Urban Design Review Panel Comments

UDRP RESPONSES

VARSITY MULTI SERVICE RE-DEVELOPMENT | JUNE 26, 2019

PROJECT + PROJECT NUMBER:	Varsity Multi-Service Redevelopment (VMSR) 18-004
OWNER/OWNER'S REPRESENTATIVE:	Christa Seepish Project Manager, The City of Calgary, Facility Management
PRIME CONSULTANT:	the marc boutin architectural collaborative inc.
DATE	August 20, 2019

Diagram #1: Design Changes to Address UDRP Responses

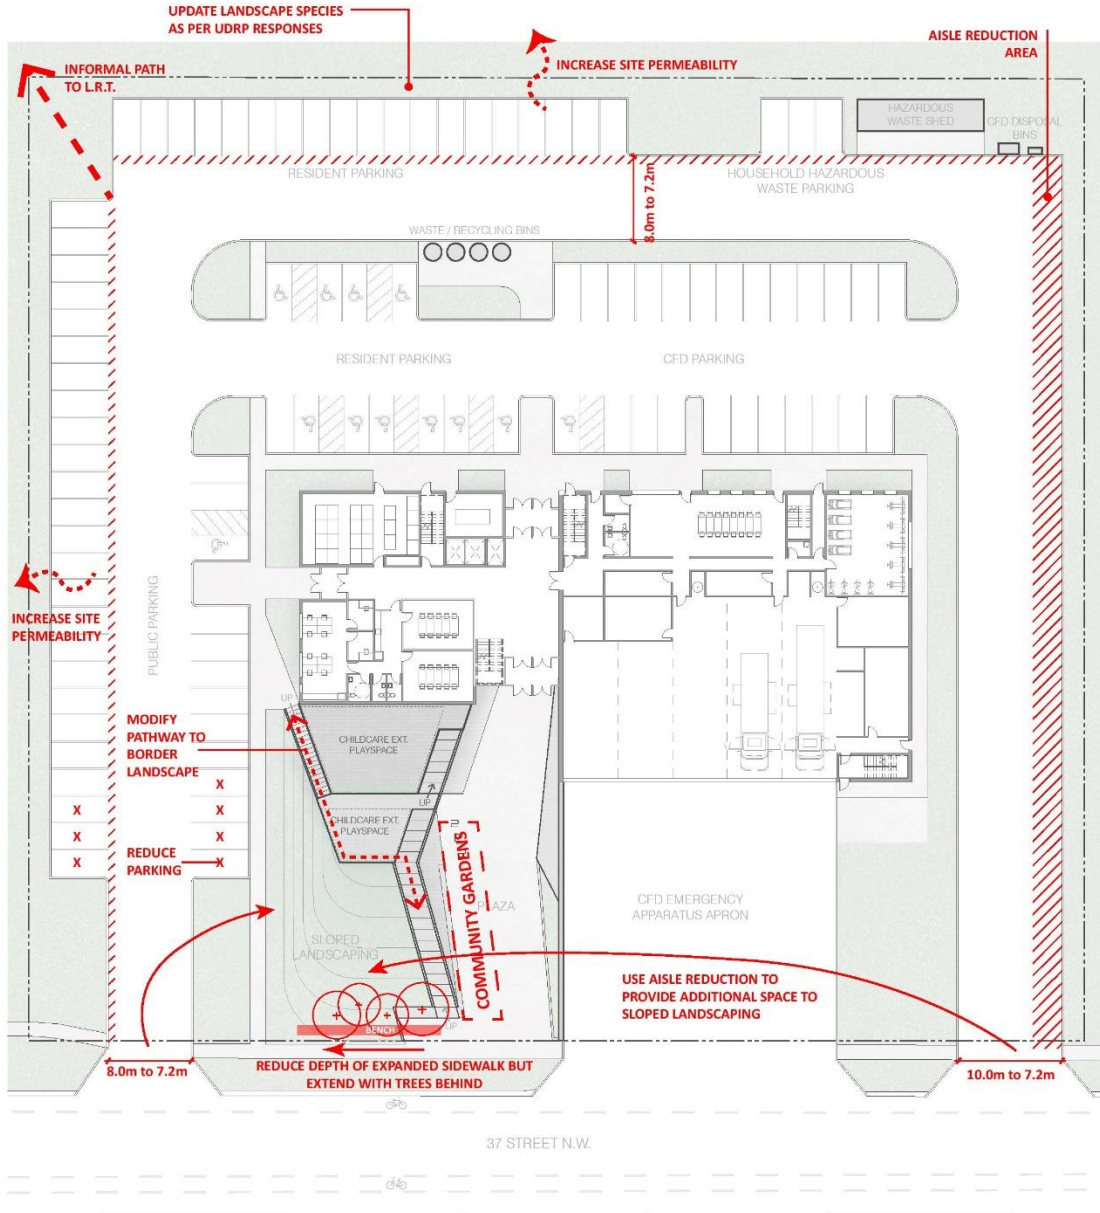
UDRP PRIMARY RECOMMENDATION:
1. The edge condition along 37th Street NW is negatively impacted by vehicular considerations above that of the pedestrian realm. As proposed, the CFD apron spans a significant width, in addition to two separate driveways, along this frontage.

2. Excessive surface parking is perceived, potentially overparked for the intended building use (as it relates to affordable housing) and the resulting layout isolates the building with a very high degree of asphalt area. Related to above, reduced parking and the

The project team appreciates the UDRP's review and recommendations, many of which are being incorporated into the project to enhance and augment the urban design realm. Refer to **Diagram #1 – Design Changes to Address UDRP Response**

RESPONSE:
Design Changes to Address UDRP Response:
- Enhanced urban design quality of 37th Street NW, including benching along 37th Street NW and further refinement to sloped landscape and child care play spaces

- Reduced width of drive aisles (north drive aisle reduced from 8m to 7.2m; south drive aisle reduced from 10m to 7.2m; east drive aisle reduced from 8m to 7.2m; reduced asphalt area added to green amenity space and site setbacks)
Clarification of Issues & Design Intentions:

Diagram #3: Park Street

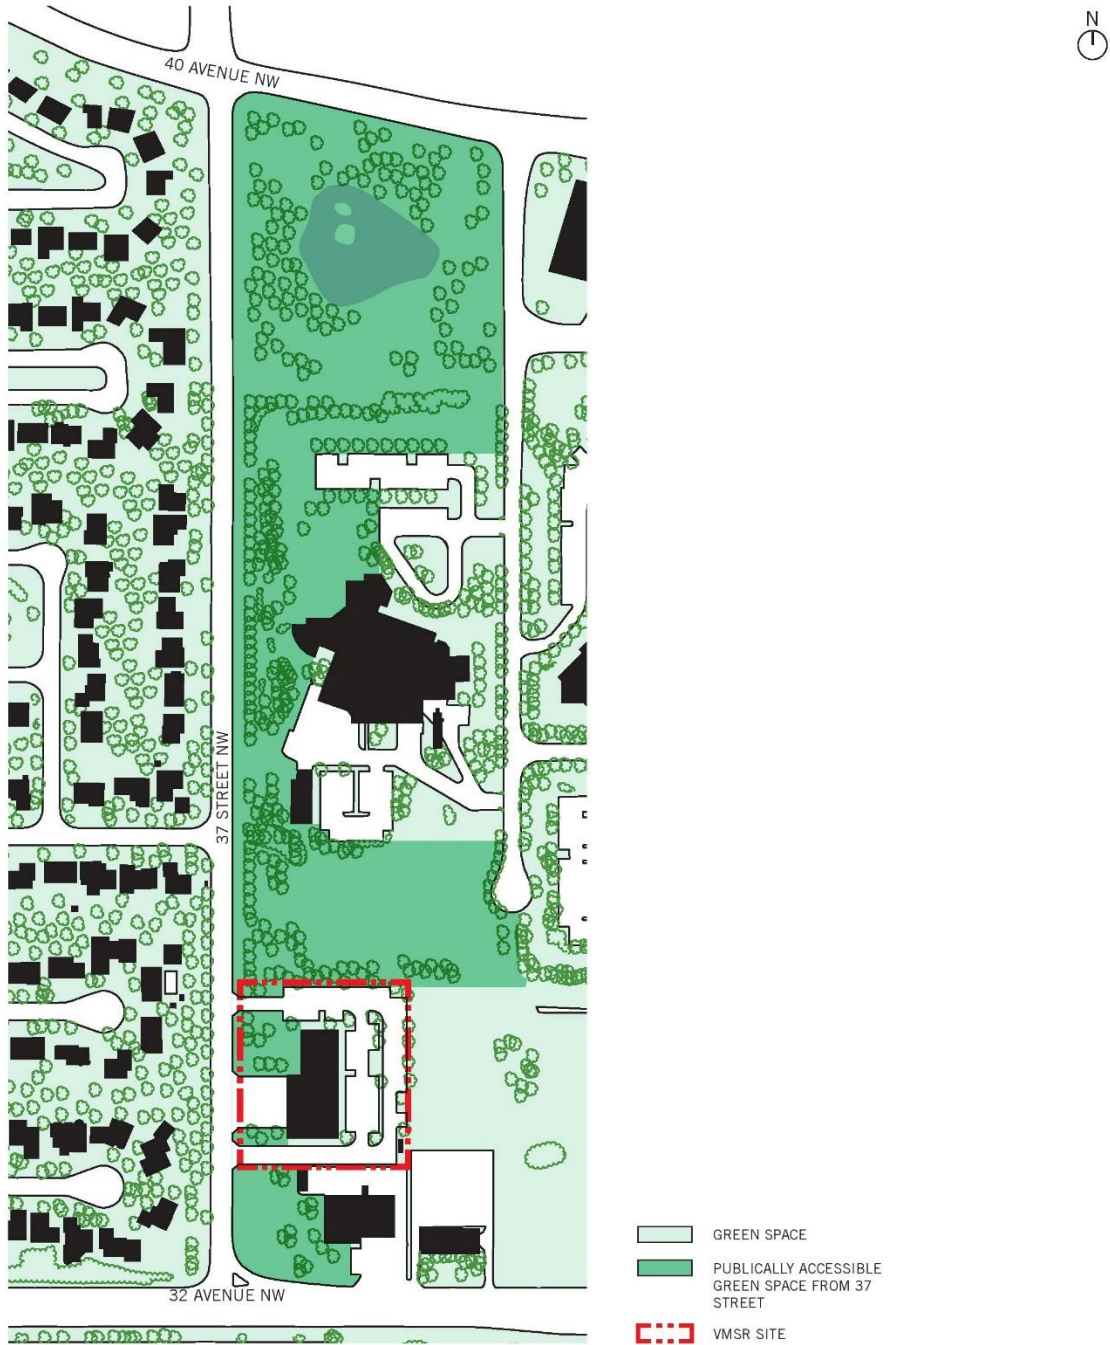
UDRP Primary Recommendation:
3. <i>Due to context, greater consideration for pedestrian connectivity must be considered. An adjustment to move the building massing towards 37th Street NW should be studied as part of this analysis.</i>

Important to arriving at this gesture is the assessment of 37th Street NW from 32nd Avenue NW to 40th Avenue NW as a residential streetscape, not a commercial or highly urban street condition. The appropriateness of including a passive green space in the design is in tune with the quality of the street due to the large set-back green areas and matured treed canopy. The street includes a west edge condition with Varsity single family residential backyards and fences abutting sod with a concrete sidewalk, trees and on-street parking. The east edge of the street includes a side walk within a substantive perceived green amenity, primarily on private property. Parking is not allowed on the east edge of the street. This is a place where people walk their dogs, students walk or cycle to the University, people make their way towards the LRT, and the public passively uses the green spaces along 37th Street NW. The mature treed canopy has been brought into the project in a more defined manner, particularly along the northwest corner of the proposed development. *Refer to Diagram #3 – A Park Street*

Diagram #4: Exterior Amenity Plan

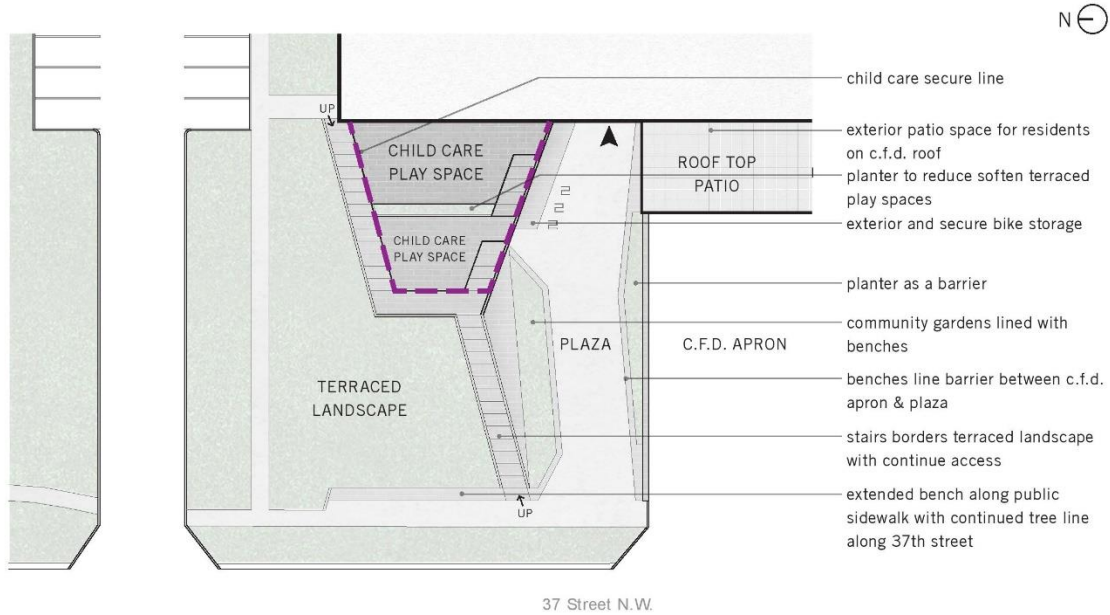
<p>ELEMENT & UDRP COMMENTARY</p> <p>03 HUMAN SCALE <i>Defines street edges, ensures height and mass respect context; pay attention to scale;</i></p> <ul style="list-style-type: none"> • <i>massing contribution to public realm at grade.</i> <p>UDRP Commentary: <i>While the fire station massing on the lower level may be fixed (due to functional requirements), the remaining building massing appears to be pushed too far from the public realm. Applicant to review shifting the rest of the building towards the street for an improved interface. This gesture could improve several aspects, including a reduction of distance in regard to the front door and the street. This consideration would also decrease the expanse of the 'plaza' area, which is relatively unprogrammed space and likely to be underutilized in the built form.</i></p> <p><i>A reinforced tree line along the street may help buffer the edge for the adjacent residents, while improving the human scale (also see Integration).</i></p>

<ul style="list-style-type: none"> • The unique overlapping of a variety of programs set-back along 37th Street NW are defined by the formal gesture of the podium and are anticipated to enhance the urban experience <ul style="list-style-type: none"> ○ An extended public bench and further planted treed canopy along 37th Street NW will be the first point of engagement for passers-by ○ The sloped landscape area with plateaued seating spaces, vegetation and connection to a unique massing element topped with tiered hardscaped secure child play spaces will have a multitude of unique spatial relationships ○ The large public plaza edged with seating, lighting and vegetation will encourage a variety of uses: <ul style="list-style-type: none"> ▪ Addition of community gardens will have more active uses from spring to fall ▪ Secure bicycle storage will bring users into the plaza, as well as a unique architectural experience of a sloped delaminated brick surface will have unique texture and light rendering qualities to experience ▪ Primary entry of the building within the plaza provides a destination point ▪ Plaza functions as a microclimate protected from north west winds by the sloped landscape, retaining walls and vegetation ▪ Views into the fire station with large glazed fire bay doors from 37th Street NW as well as carved views from the plaza, also will welcome pedestrians into the plaza to get a closer glimpse of the fire trucks ○ On the south edge of the podium, the honorific configuration celebrating the placeness of the program ○ A low landscape wall signifying the building's identity and address anchors the south edge of the plaza with seating and separates the fire station apron ○ A resident resource room with planter boxes that overlooks the public plaza below will further enhance public use and a combination of a variety of uses day to night • In developing the above conditions, it is the project team's opinion that a higher quality urban environment is generated by creating exterior public spaces along 37th Street NW as opposed to moving a private building closer to the street side which does not provide public amenities • Refer to Diagram #4 – Amenity Plan

Diagram #6: Landscaping Strategy

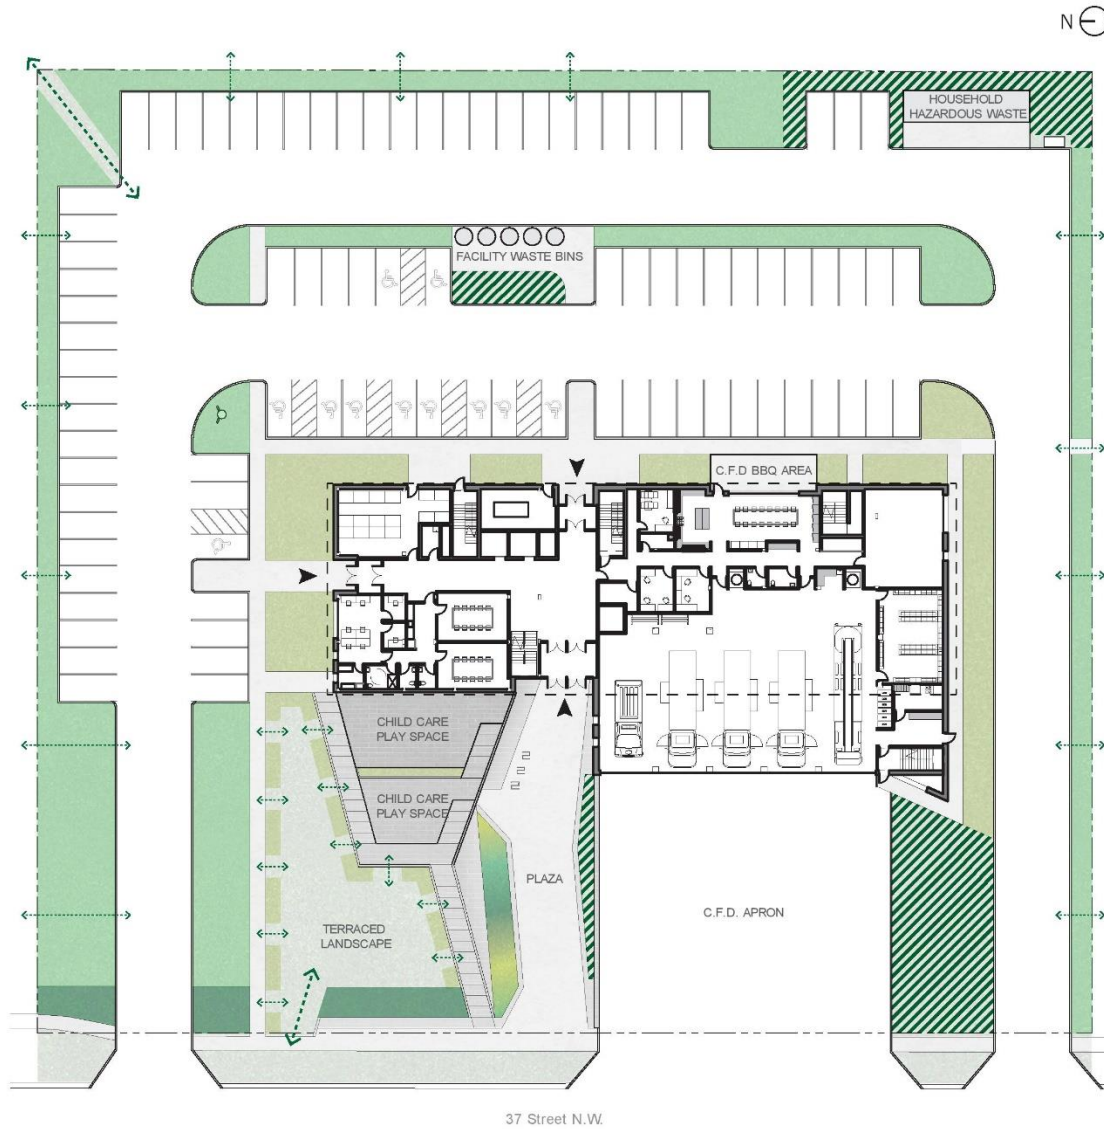
<p>ELEMENT & UDRP COMMENTARY</p> <p>04 INTEGRATION</p> <p><i>The conjunction of land-use, built form, landscaping and public realm design</i></p> <ul style="list-style-type: none"> • Parking entrances and at-grade parking areas are concealed • Weather protection at entrances and solar exposure for outdoor public areas • Winter city response <p>UDRP Commentary:</p> <p><i>Integration of 37th Street NW with the public realm is negatively impacted by previously noted vehicular considerations. It is perceived that over 50% of this edge condition is composed of asphalt. The Panel appreciates CFD requirements for the expansive apron, however, challenge the applicant to review the degree interruption of the sidewalk condition. Applicant/owner to review reduced surface parking requirements and the elimination of a driveway access, which would significantly improve the integration along this edge.</i></p> <p><i>The landscape plan shows the site surrounded on three sides by a continuous treed edge, which isolates the site from the potential of a shared landscape (as it relates to the adjacent open space areas). Conversely, a continuous treed edge is perceived to be more appropriate along 37th Street for a better interface with the adjacent residential area. Applicant to review the overall landscape strategy for a unified approach to the surrounding edge conditions.</i></p>

RESPONSE:
Design Changes to Address UDRP Response:
<ul style="list-style-type: none"> - Further refinement of a landscaping strategy, including bringing the mature treed canopy along 37th Street NW into the project's green spaces and increased permeability of the design along the project's boundaries by revising the planting strategy to be less dense - Pedestrian connectivity has been enhanced by further programming of the plaza with the inclusion of a community garden, enhanced pedestrian use and movement within the sloped landscape to not bi-sect the daycare terraced play spaces and providing a connection to existing desire lines. The public stairs adjacent to the terraced child care play spaces are located along the edge of the play spaces, and allow for complete public access of the sloped landscape, while maintaining one point of secure access for the exterior child care play spaces. - <i>Refer to Diagram #6 – Landscape Strategy</i>

<p>RESPONSE</p> <p>Design Changes to Address UDRP Response:</p> <p>Pedestrian connectivity has been enhanced by further programming of the plaza with the inclusion of a community garden, enhanced pedestrian use and movement within the sloped landscape to better respond to the daycare amenity space and providing a connection to existing desire lines</p> <p>Permeable Site Edges (North, East, and South):</p> <ul style="list-style-type: none"> • The landscaped edge of the site on its north, east, and south property lines has been modified to allow for pedestrian crossing from adjacent green spaces. A pathway has been created from the site sidewalks to the northeast corner of the site to take into consideration the use of the nearby LRT station by the project users. As the pathway to the northeast corner would encourage the trespass of private properties it is proposed that the pathway remain informal, using materials such as crushed gravel. If in the future the surrounding properties are developed and support the pathway to the LRT, it is anticipated the pathway would become formalized. • The northeast corner was considered to be the ideal location for an informal path in anticipation of future development as it is at the corner of the four abutting properties. If any of these private properties are developed, or if 36th Street NW is extended, the pathway could continue along the property lines east, in an unobtrusive manner. <p>Landscape Plan Refinement & Continuous Treed Edge:</p> <ul style="list-style-type: none"> • Refer to <i>Human Scale</i> <p>Refer to Diagram #6 - Landscaping Strategy</p>
